MILITARY SPECIFICATION

MECHANISM, RECOIL, 155MM HOWITZER: M45

This amendment forms a part of Military Specification MIL-M-45986 (WC), dated 15 February 1977, and is approved for use by the US Army Armament Munitions and Chemical Command, and is available for use by all Departments and Agencies of the Department of Defense.

FIGURE 1 TYPICAL ROD PULL CURVES

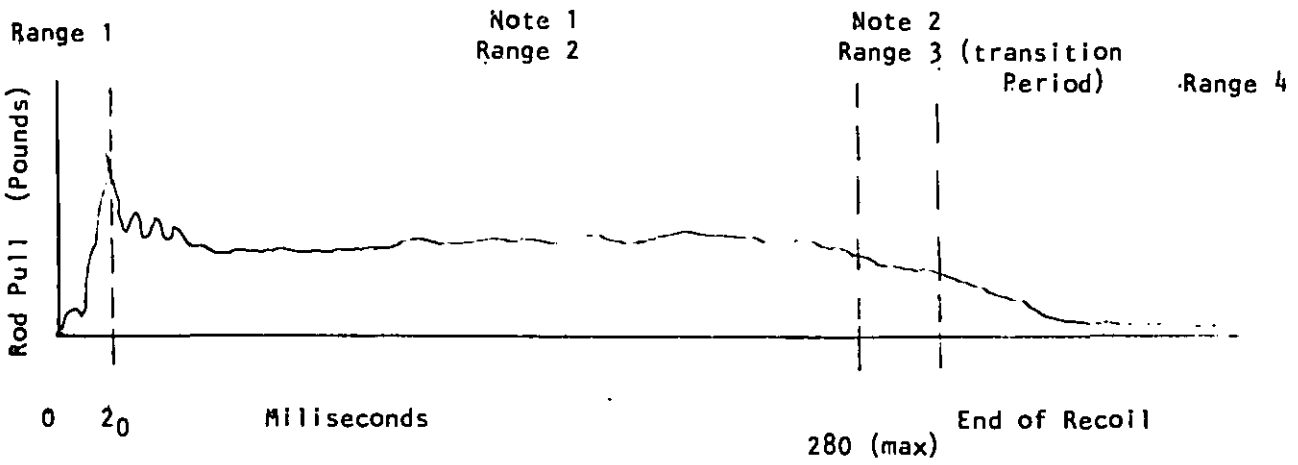
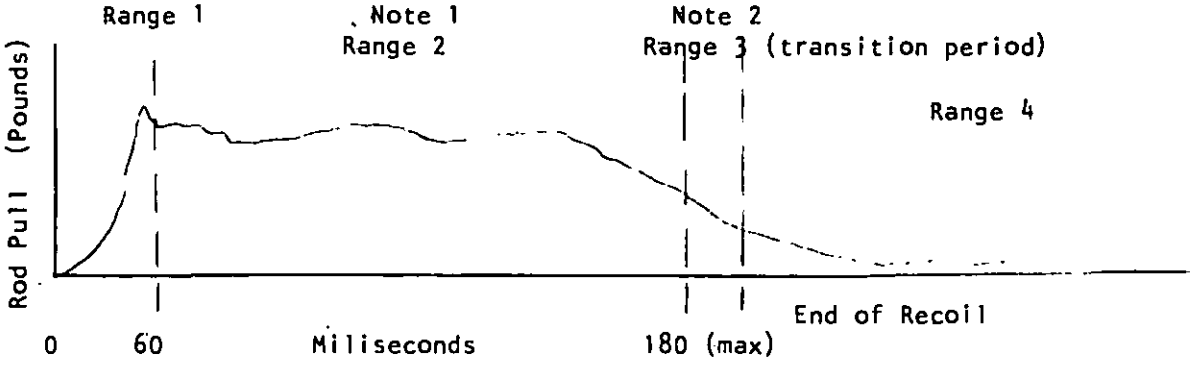
3.3.2.5 Rod pull curves. The actual rod curves shall meet the following requirements: (see Figure 1)

Range 1: Peak rod pull shall occur within the first 20 milliseconds for long recoil and 60 milliseconds for short recoil.

Range 2: Within 280 miliseconds for long recoil or 180 miliseconds for short recoil, the continuous rod pull curve shall not exceed the peak rod pull of range 1.

Range 3: After Range 2, the rod pull curve shall be continuously declining to the end of the recoil cycle.

Range 4: Counter recoil cycle. See paragraph 3.3.2.4."

Delete original Figure 1 and substitute new Figure 1.

Note 1: Rod pull trace is allowed to increase or decrease within the range as long as it does not exceed the peak in Range 1.

Note 2: Rod pull trace must be continuously decreasing in this range to the end of the recoil cycle.
